U.S. Department
of Transportation
Federal Aviation
Administration

Advisory Circular

Subject: Dynamic Evaluation of Seat Restraint Systems and Occupant Protection on Transport Airplanes

AC No: 25.562-1B
Change: 1

Figure 5-2. Structural Test Article Decision Tree for Seat Family

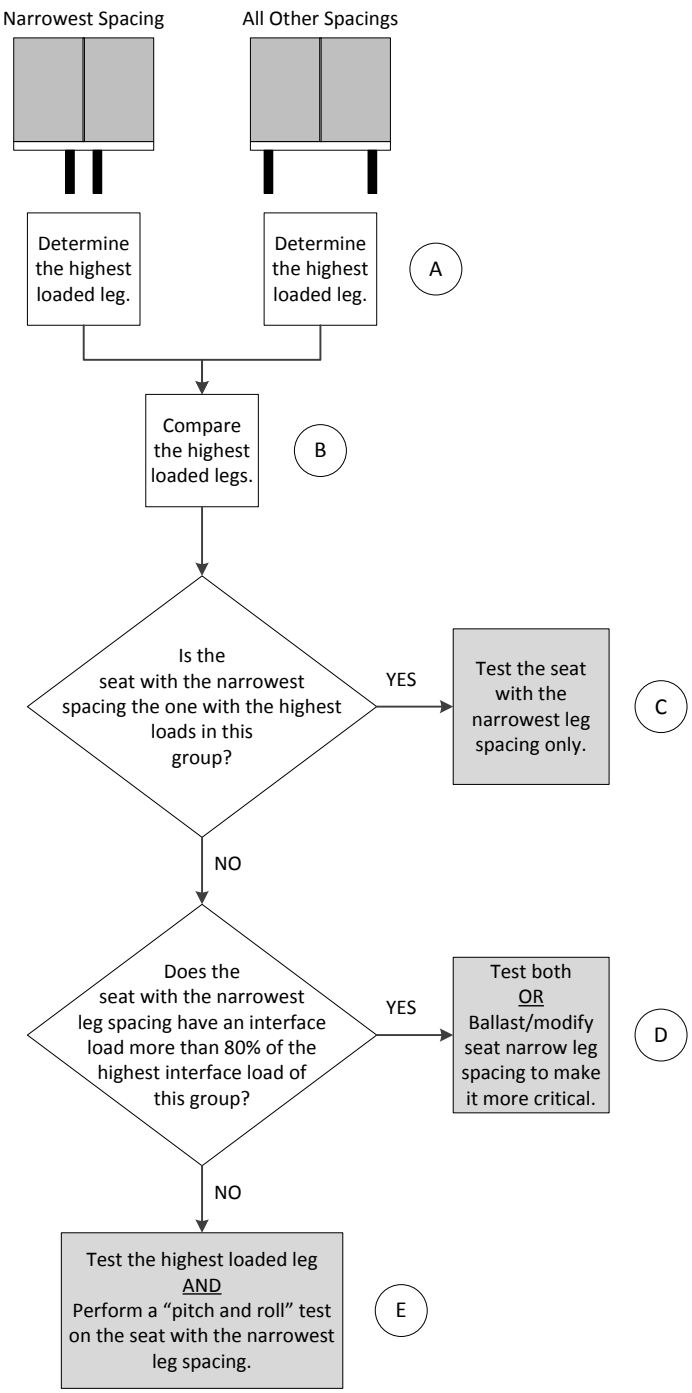
b. Corrects typographical errors in the second question of Figure 5-2. We also redesigned the figure to improve readability.
